Eliminating Symptoms - Engine: Reworking Coolant Pipe (Loss of coolant at the coolant pipe/SY1416)

Model Lines: Sports Cars (981/991)

Model Year: **As of 2014 up to 2016**

Coolant pipe on coolant regulator housing

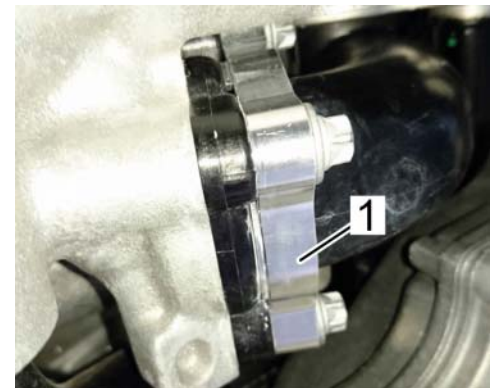
- 2 Unscrew screws ⇒ *Coolant pipe on coolant regulator housing -1-* on the coolant regulator housing
⇒ *Coolant pipe on coolant regulator housing -3-*.

Installing water tube retaining bar

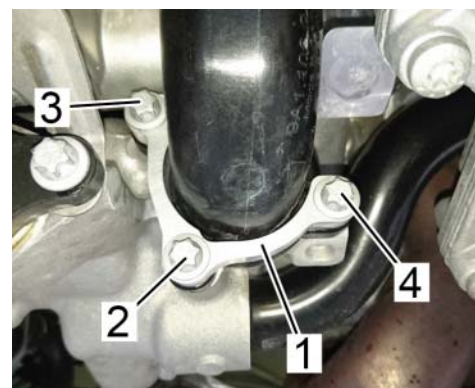
- 3 Clean sealing surface for water tube retaining bar on the flange thoroughly with a cloth.
- 4 Install water tube retaining bar ⇒ *Installing water tube retaining bar -1-*, Part No.: 9A1.106.338.00, using **new** longer screws (M6 x 35), Part No.: 900.385.270.01.
- 5 Tighten screws ⇒ *Screwing in screws -2 to 4-* in the sequence ⇒ *Screwing in screws -2, 3, 4-*.
Tightening torque 13 Nm (9.5 ftlb.)
- 6 Re-tighten screws ⇒ *Screwing in screws -2 to 4-* again in the same sequence. ⇒ Tightening torque 13 Nm (9.5 ftlb.)
